1.0 INTRODUCTION

This non-material amendment relates to a portion of the works to the stone stables outbuilding which were granted as part of the planning and listed building consent (23/00037/HOUSE - granted 12.05.23) and (23/00038/LBCALT - granted 17.03.23)

2.0 PROPOSED CHANGE TO SOUTH AND WEST ELEVATIONS

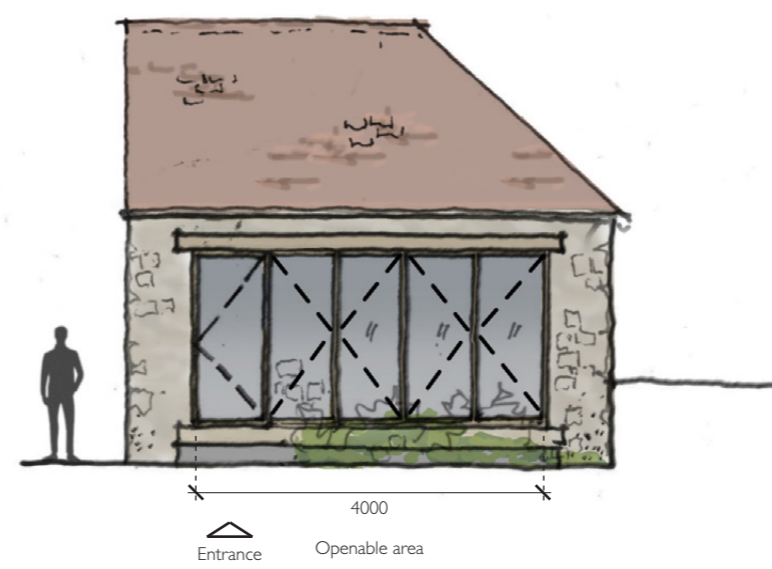
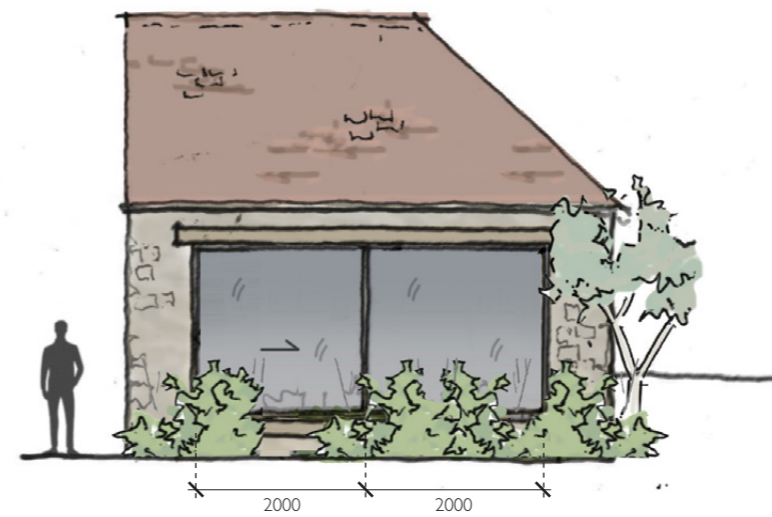
The south and west elevation walls of the Art Studio 00.17 are to be rebuilt in ragstone with new timber windows and doors introduced. The entrance to the Art Studio is now to be via the west elevation rather than the south elevation, leading us to revisit the design of these openings. Namely the introduction of an outward opening swing door to the west elevation and sliding glazing to the south.

The intention is to maintain the strong interior/exterior connection while not inhibiting internal space, as well as referencing the new proposed Gym building (23/01529/HOUSE - granted 02.08.23) which is to be built in ragstone with sliding doors. Note the overall opening sizes remain consistent. Refer to the following page for an alongside comparison illustrating the change.

- Entrance to Art Studio in South elevation up paved steps.
- Bi-fold timber doors to South elevation.
- Large triple timber window in West elevation.

- Entrance to Art Studio in West elevation up paved steps.
- Sliding glazed timber windows to South elevation to same overall dimensions as previously consented (to act as opening only, not circulation route).
- Glazed timber entrance door with glazed timber fixed side panel to same overall dimensions as previously consented.
